5.2. Built Form

Building Height and Setback

Figure 10: Sydney LEP 2005 height controls. The subject site is outlined in black.

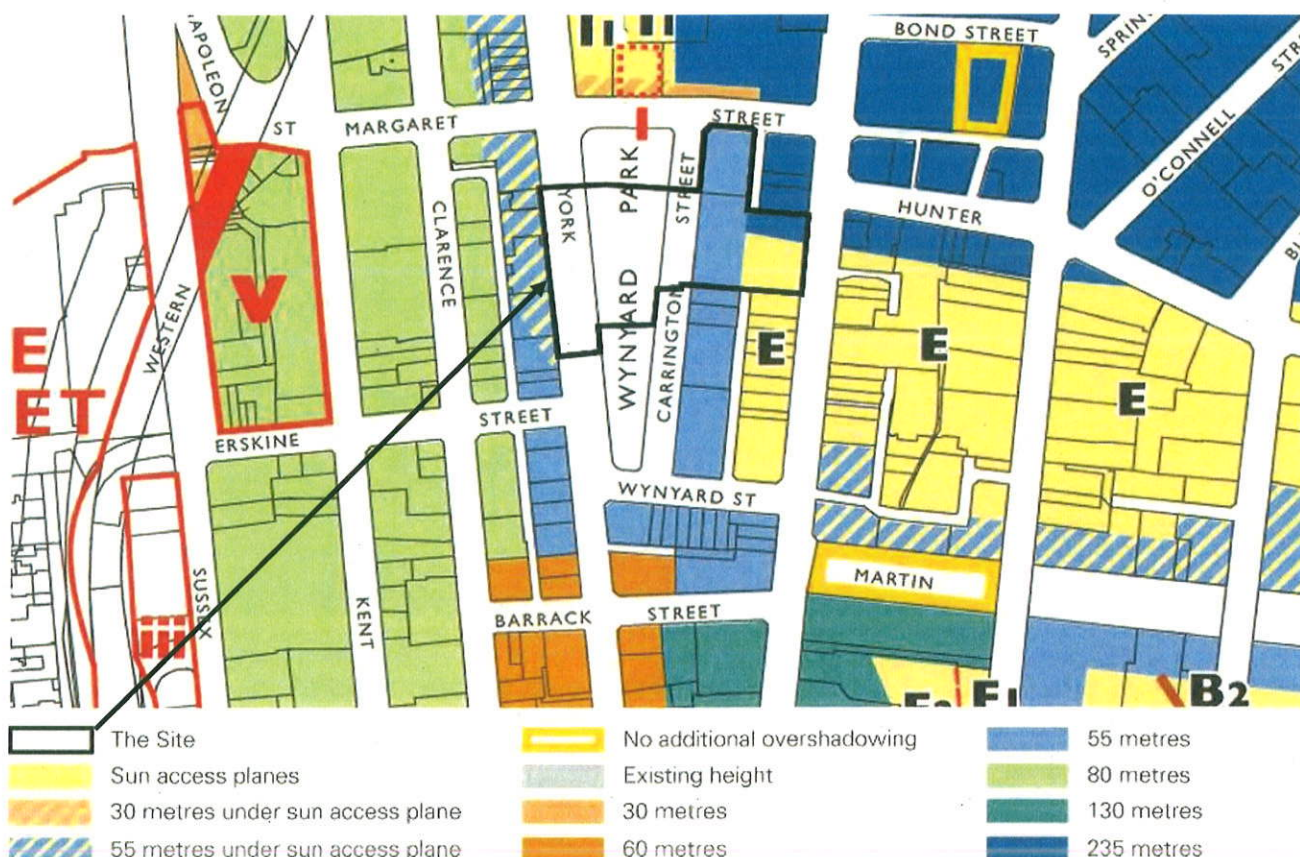
The site is subject to a number of maximum height controls under SLEP 2005 (**Figure 10**):

- the northern portion of the George Street frontage to the east allows for development up to a height of 235 metres;
- the southern portion of the George Street frontage to the east is controlled by a sun access plane to Martin Place; and
- the western side of the site along the Carrington Street frontage allows development up to a height of 55 metres.

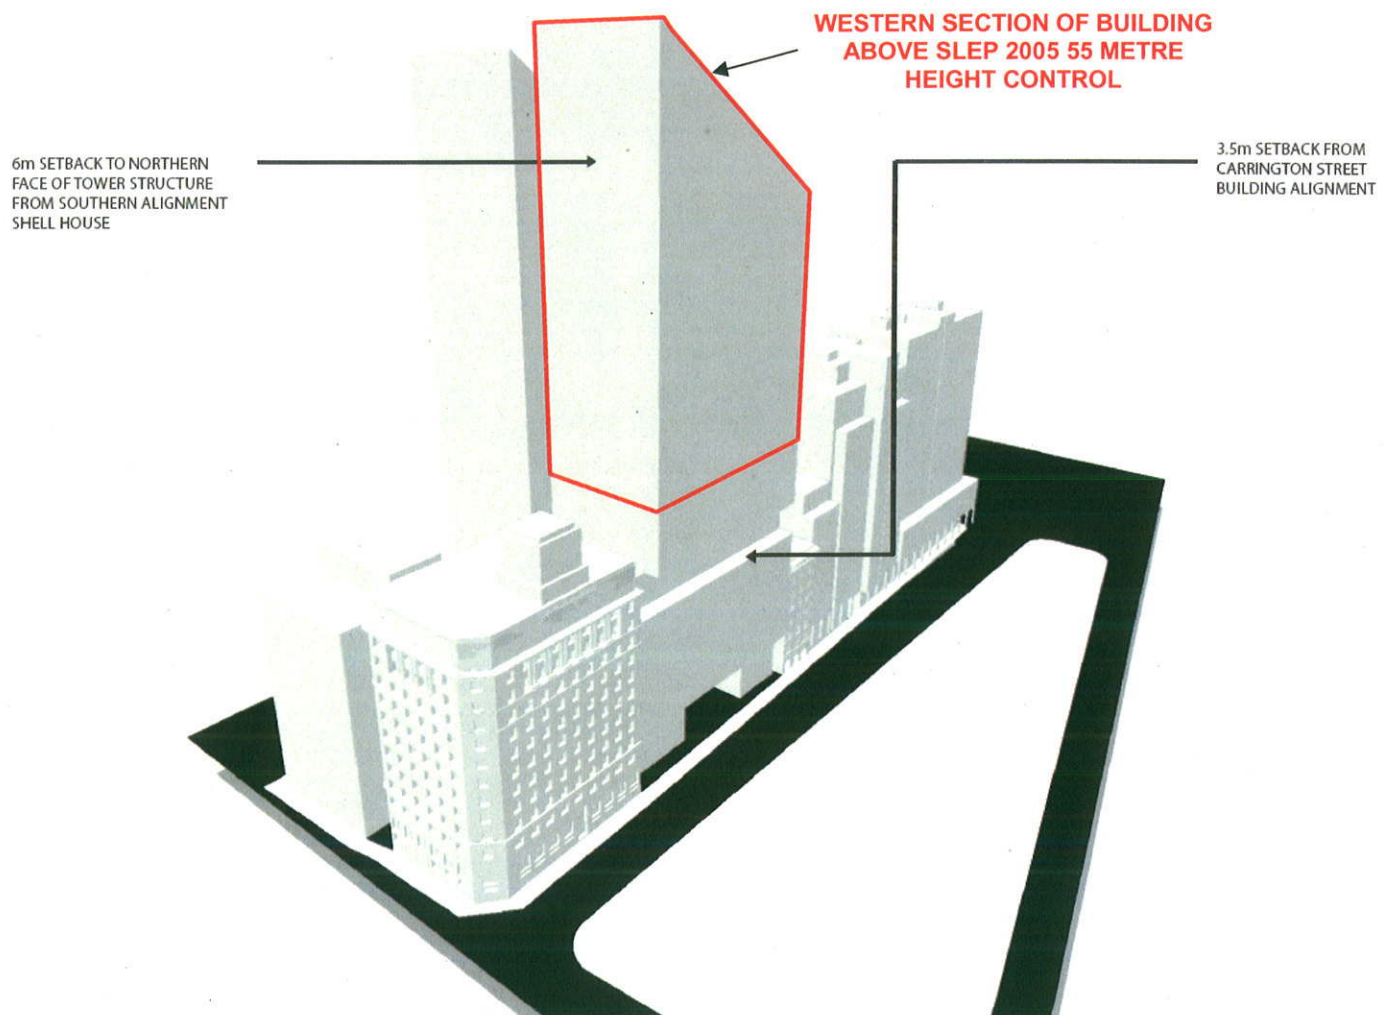
The height of the proposed envelope complies with the LEP height controls, with the exception of the western portion of the proposal. The western portion of the proposed envelope (situated between Wynyard Lane and Carrington Street) exceeds the 55 metre height control along the Carrington Street frontage by between 58 to 91 metres. This non-compliance is illustrated in **Figure 11** below.

Figure 13: Aerial view looking from the north of Wynyard Park toward the south. The red broken line follows the defined street wall height surrounding Wynyard Park.

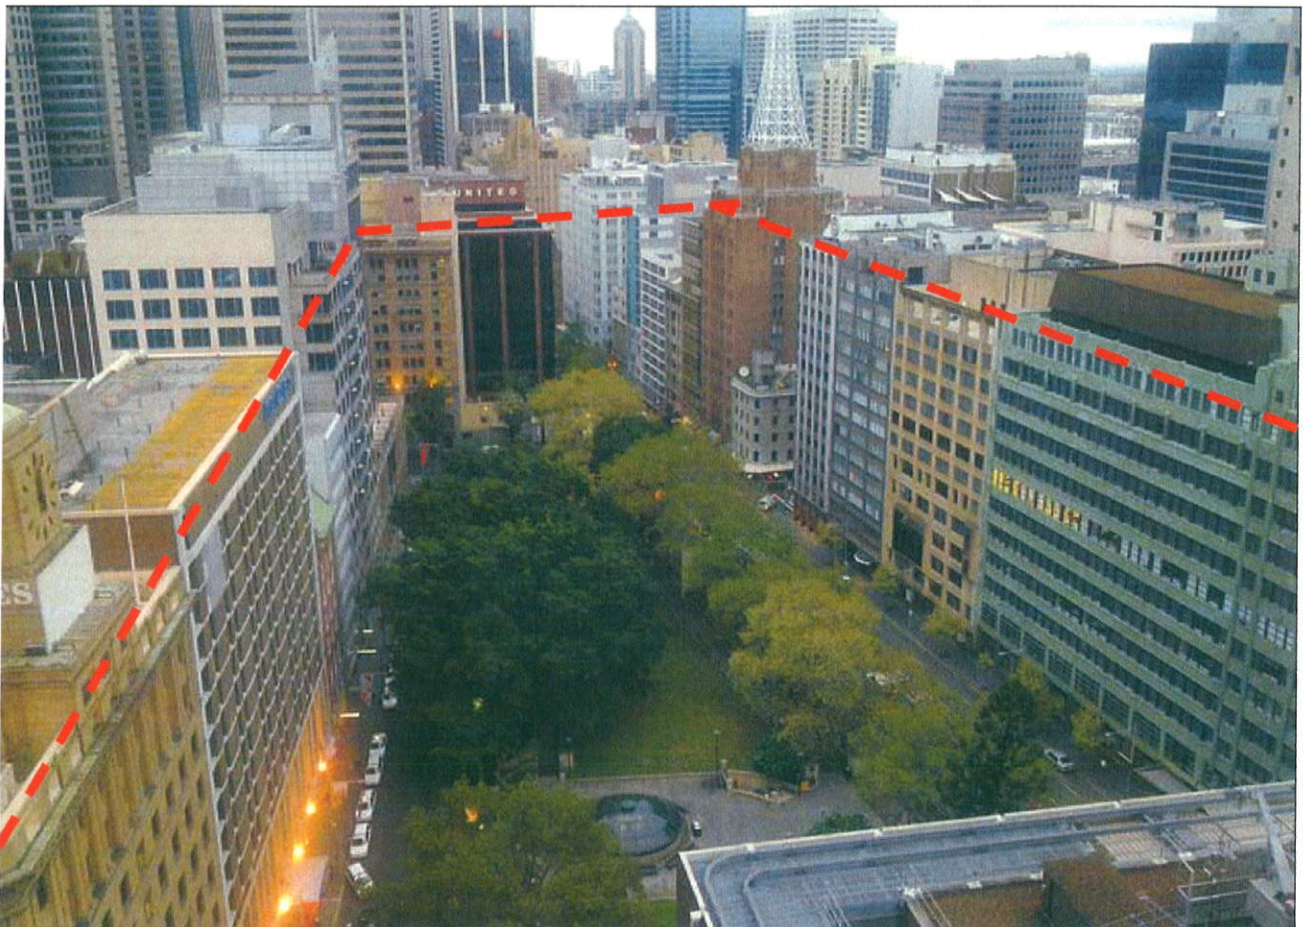
As illustrated in Figure 13, the buildings surrounding Wynyard Park provide a street wall to maintain a sense of enclosure around Wynyard Park. Given the overall height of the proposed building envelope and the 55 metre height limit in SLEP 2005, the Department considers that the composition of the western façade and its presentation to Carrington Street and Wynyard Park is a critical design issue.

The Department therefore recommends a podium form having a height matching the existing Shell House parapet along the Carrington Street frontage with a minimum 3 metre upper level setback provided for the tower form above this height (this includes the additional level above Shell House).

Figure 14: The additional shadowing to the western end of Martin Place created by the proposed building envelope at 12:45 at mid-winter is shown in yellow and the existing shadow is shown in dark grey.

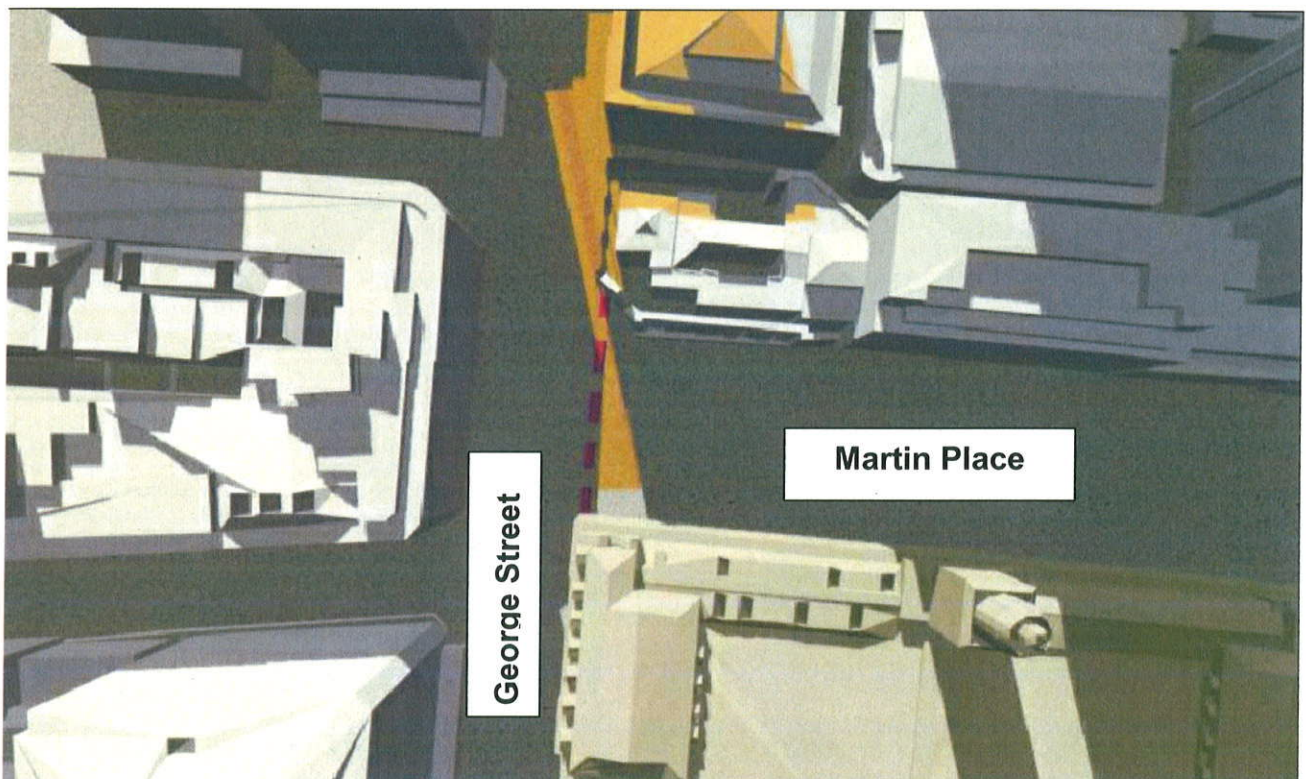
demonstrates that the proposed envelope results in additional overshadowing of a small triangular portion (ranging between approximately 10-45m²) of Martin Place adjacent to George Street for the period between 12:15-1:15pm at the winter solstice (**Figure 14**). The SLEP 2005 prohibits development which results in a building that causes additional overshadowing to Martin Place between 12noon-2pm between 14 April and 31 August.

Council has submitted their own shadow modelling undertaken for the proposal at mid-winter indicating that at 12:30pm a narrow triangle of sun on Martin Place is removed, however by 1:00pm the additional overshadowing is so minor it would be imperceptible. This is a slightly lesser impact than indicated by the EA. The Council describes this as minimal additional overshadowing and has placed more importance on the issue of any additional overshadowing to the GPO steps and façade, which are not overshadowed by the Proponent.

The Department considers that the overshadowing impact to Martin Place is minimal and will not have any significant solar access impact to Martin Place. The Proponent's surveyor has confirmed that it would be necessary to lower the overall height of the proposed building envelope by approximately 19 metres (approximately 5 storeys) in order to eliminate this overshadowing. The absence of any significant impact is considered not to warrant further modification of the proposed building envelope.
